UNITED STATES
NUCLEAR REGULATORY COMMISSION
WASHINGTON, D. C. 20555

The Commission has issued the enclosed Amendment Nos. 68 and 50 to Facility Operating License Nos. DPR-53 and DPR-69 For Calvert Cliffs Nuclear Power Plant, Unit Nos. 1 and 2. These amendments consist of changes to the Technical Specifications in response to your application dated January 22, 1982.

AMENDMENT TO FACILITY OPERATING LICENSE

SAFETY EVALUATION BY THE OFFICE OF NUCLEAR REACTOR REGULATION

FIGURE 6.2-1
MANAGEMENT ORGANIZATION CHART
CALVERT CLIFFS NUCLEAR POWER PLANT
BALTIMORE GAS & ELECTRIC COMPANY

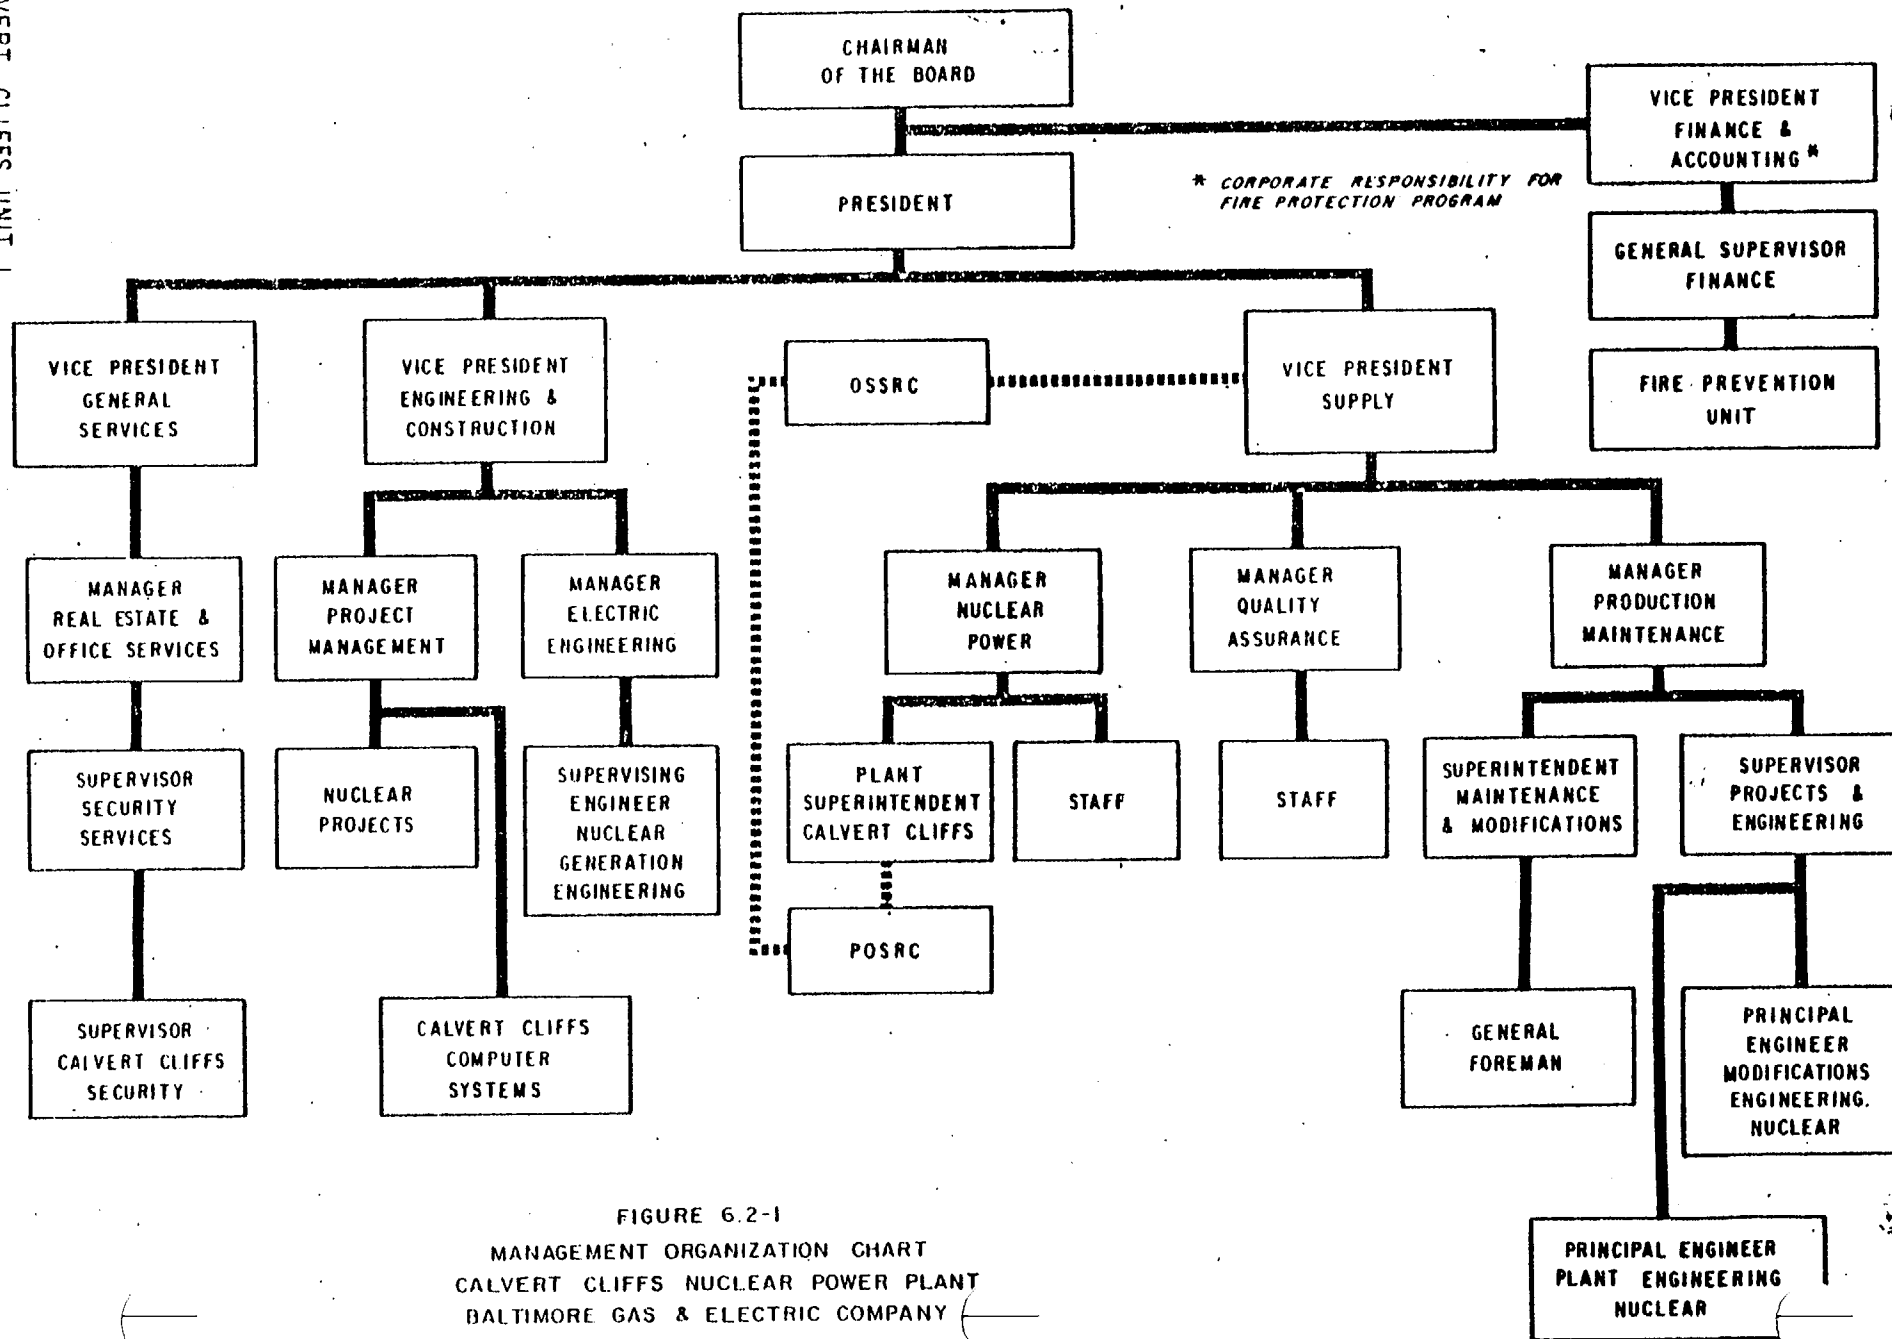
The requirements of Appendix A TS 6.2.1 specify the Calvert Cliffs off-site organization for facility management and technical support. In a similar manner, Appendix B TS 5.2 specifies the plant and corporate organization relative to environmental matters at Calvert Cliffs. As a result of a recent reorganization at BG&E, Appendix A TS 6.2.1 and Appendix B TS 5.2 are amended by providing updated organization charts which reflect these recent changes. In addition, the shift staffing requirements of Appendix A TS 6.2.2a are amended to be consistent with the requirements of NUREG-0737, Item I.A.1.3.2. The change results in the requirement for an additional licensed (OL) operator, resulting in a total of three operators on shift duty, when one unit is in operation while the other unit is shut down. It is our intent that only two of the three OLs be required to be in the control room at any given time under the above referenced conditions. The shift staffing requirements, specified when one unit is in operation with the second unit defueled are deleted consistent with NUREG-0737, Item I.A.3.2. Accordingly, we conclude that the shift staffing requirements for Calvert Cliffs are consistent with NUREG-0737 Item I.A.3.2. Since the remaining part of Item I.A.1.3, "Limiting Overtime" (Item I.A.1.3.1) was approved for Calvert Cliffs via NRC letter dated November 3, 1981, our review of Item I.A.1.3 is complete for Calvert Cliffs Units 1 and 2.

6.2.1 The offsite organization for facility management and technical support shall be as shown on Figure 6.2-1.
